County of San Diego
Planning & Development Services
BUILDING DIVISION

ACCESSIBILITY CORRECTION LIST

Multifamily Housing

Public Telephones

(c) FORWARD REACH ARRANGEMENT

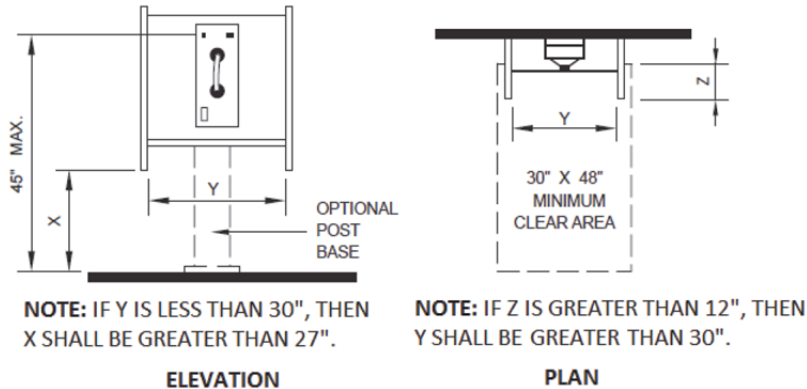
6. Dimension telephone mounting height and any enclosures per the following:
 - ☐ Where only forward approach allowed, per CBC Figure 11A-11B(c)

(a) SIDE REACH ARRANGEMENT

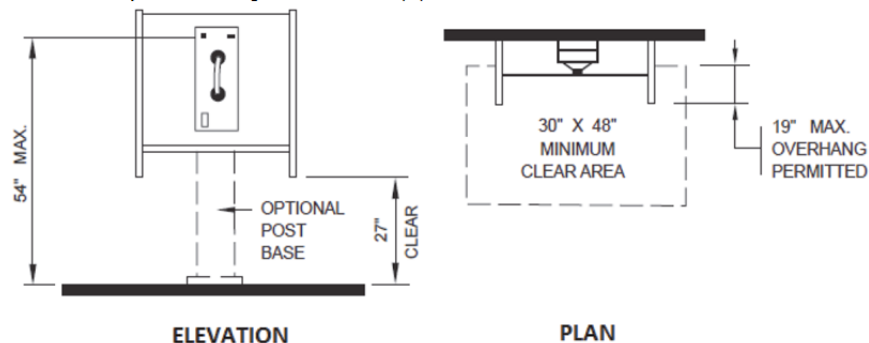
- ☐ Where parallel approach allowed, per CBC Figure 11A-11B(a)

(b) FULL HEIGHT ENCLOSURE

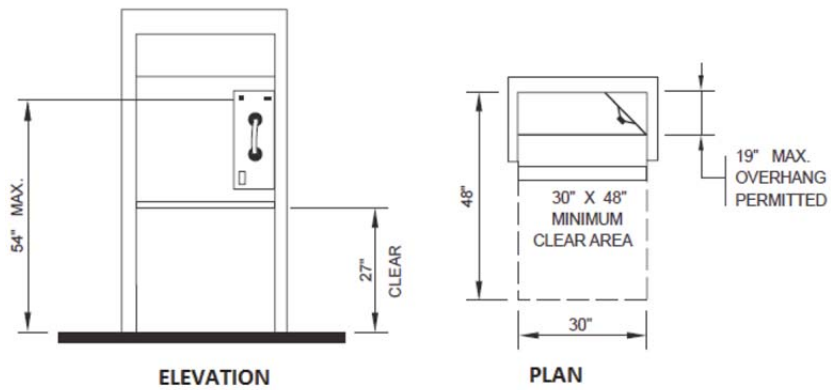
- Where enclosure is full-height or telephone mounted in corner requiring wheelchair users to reach diagonally, per CBC Figure 11A-11B(b)
